MODEL  
**Sedona, Sorento, Amanti,  
Optima, Rondo**

NUMBER  
**044 [Revised]**

## TECHNICAL SERVICE BULLETIN

ECM UPGRADE WITH TP SENSOR REPLACEMENT – MIL ON WITH DTC P2135 / P0638

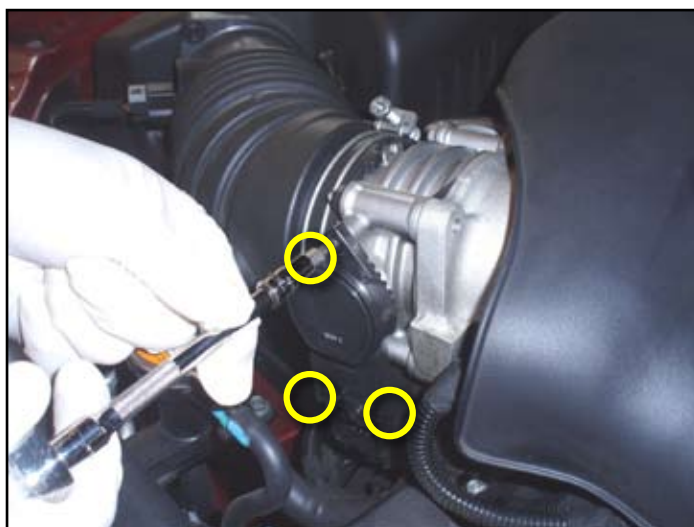
Part Name	Part Number		Part Kit	
Throttle Position Sensor (TPS)	Optima/Rondo with 2.7L	35107 3E000FFF or 35107 3E100FFF	1. TP Sensor 2. O-ring 3. Screws*	 or 
	Sedona, Sorento and Amanti with 3.3L or 3.8L	35107 3C000FFF or 35107 3C100FFF

***\*Only supplied w/3C100FFF***

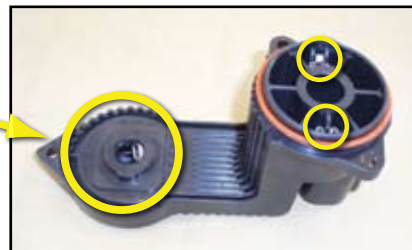
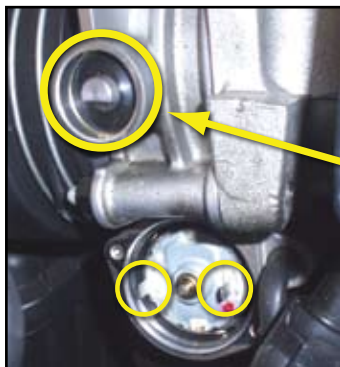
3. Remove the three (3) torx mounting screws (T-20).

4. Remove the TP sensor from the ETC actuator.

**The O-ring sometimes will stick to the housing during removal.  
Be sure to remove if this occurs.**
